# Roland SERVICE INFORMATION

JP-8

About alteration on JP-8 Service Note

TO SERVICE ENGINEERS: SUBJECT  
Hum and Sound leakage

DRAWING No.1

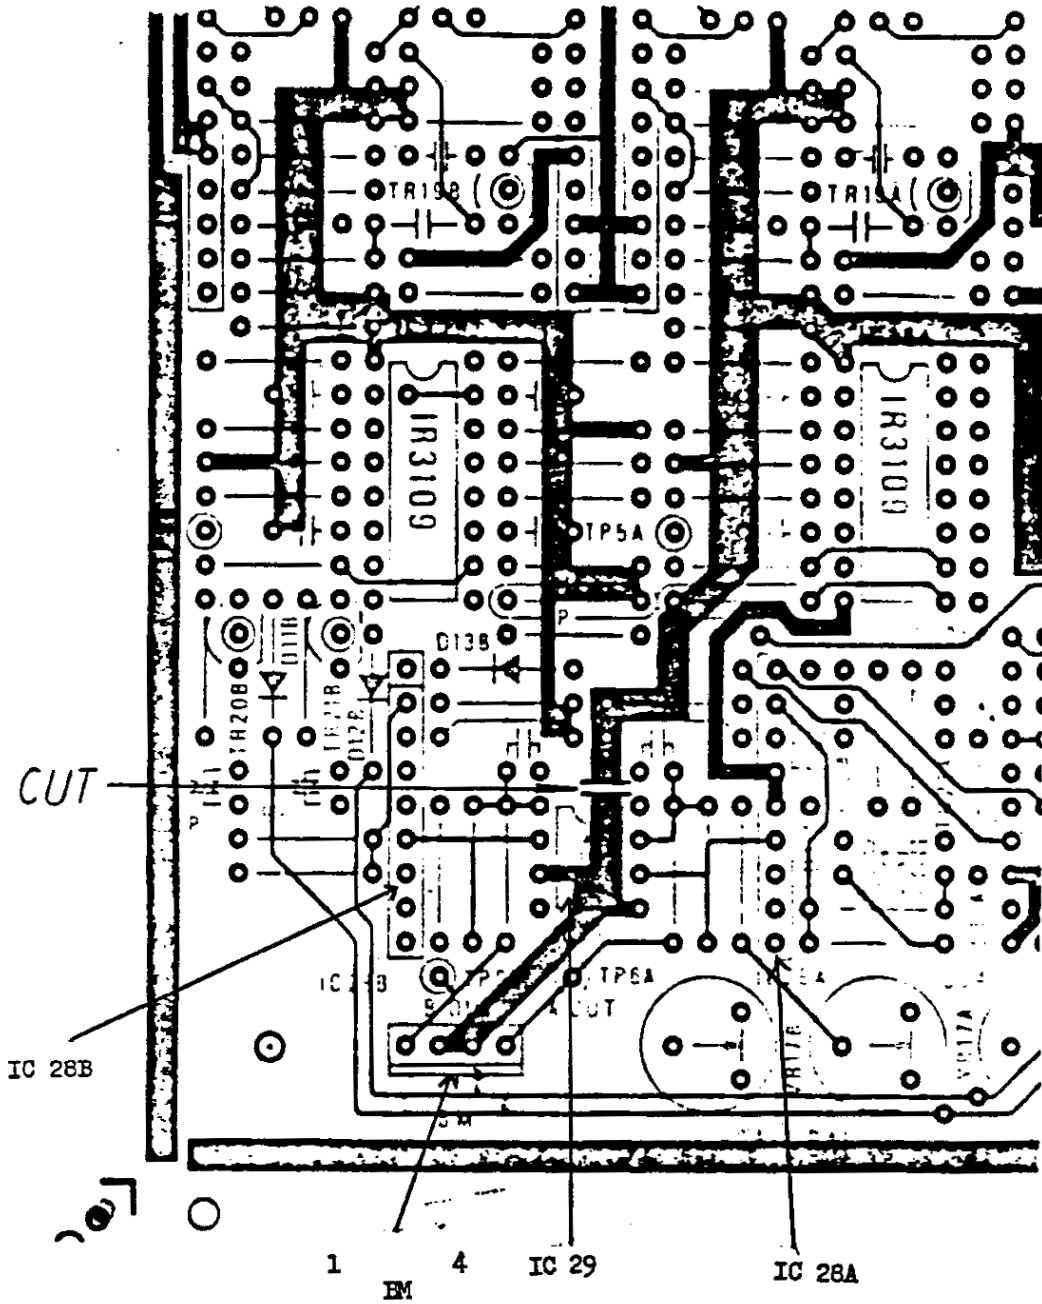
STEP 1 : Cut off a part of a pattern on the "Component Side" Confer the enclosed drawing No.1.

部品面 パターンカット 1ヶ所 COMPONENT SIDE

DRAWING No.2

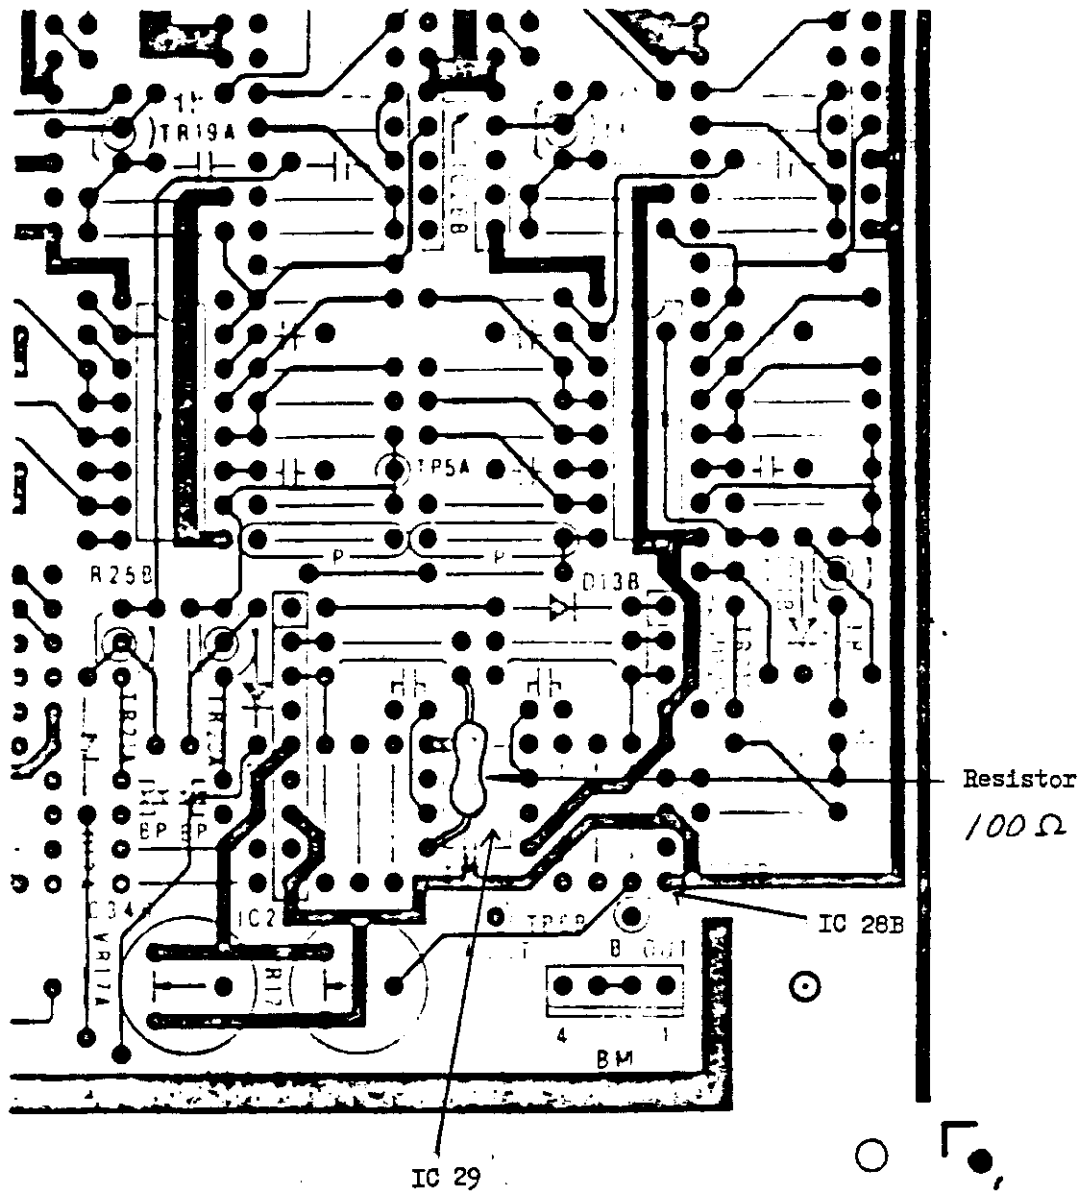
STEP 2 : Add a new resistor 100 ohm to each Module Board at the place where the pattern is cut off (to cut a ground loop) on the "Foil Side". Confer the drawing No.2.

半田面 抵抗100 $\Omega$ 裏付1ヶ所
